ISO/IEC 14443-4

First edition
2001-02-01
AMENDMENT 1
2006-03-15

Part 4:
Transmission protocol

AMENDMENT 1: Handling of reserved fields and values

In Figure 10, remove the arrows and RFU and link up bits b8 to b5 in one arrow marked as (1101)b as follows:

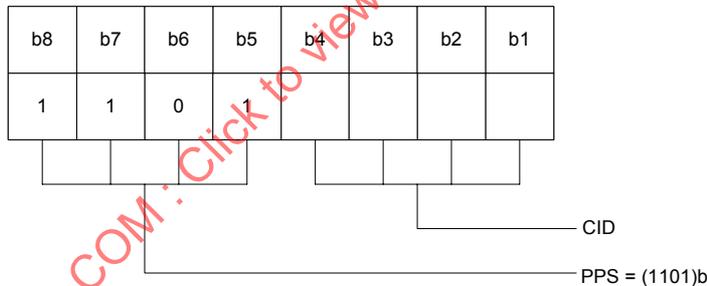
Page 10, Subclause 5.3.1 "Start byte"

Replace the first list item with the following:

"
⎯ The most significant half byte b8 to b5 shall be set to (1101)b and identifies the PPS.
"

b8	b7	b6	b5	b4	b3	b2	b1
1	1	0	1

CID

PPS = (1101)b
